GOVERNMENT OF INDIA
MINISTRY OF ENVIRONMENT & FORESTS
Central Zoo Authority

F. No. 19-20/92-CZA(325)(Vol. VII)(M)/317

Sub:- Power point presentation on the proposed works to be taken at Dowhill, Topkedara, Gairibas and Darjeeling.

CROSS SECTION SHOWING THE RETAINING WALL OF UPGRADATION & ENRICHMENT OF SOFT REALEASE FACILITY OF RED PANDAS AT GAIRIBAS, SINGHILALA NATIONAL PARK UNDER PNHZ PARK, DARJEELING

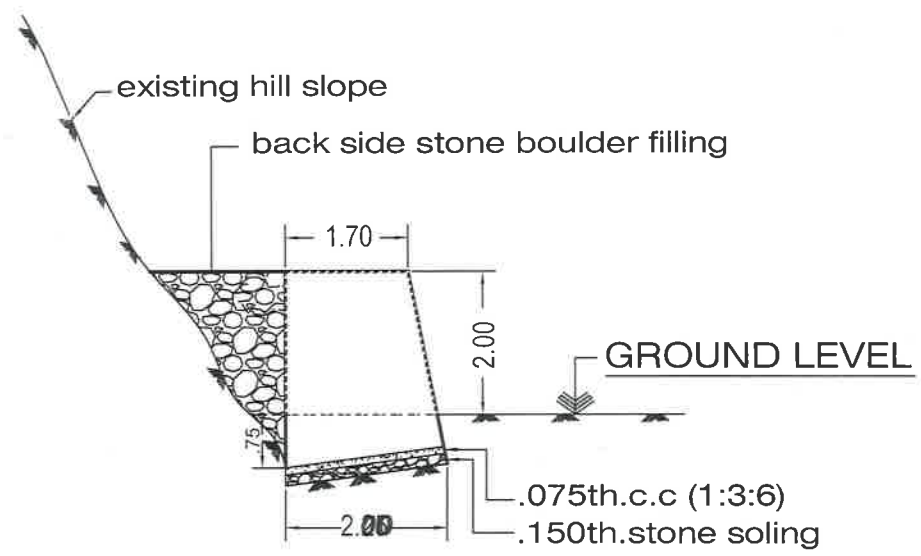
- (vi) Upgradation and enrichment of soft release facility of Red panda at Gairibas under PNHZPark.

The design was scrutinized and approved.
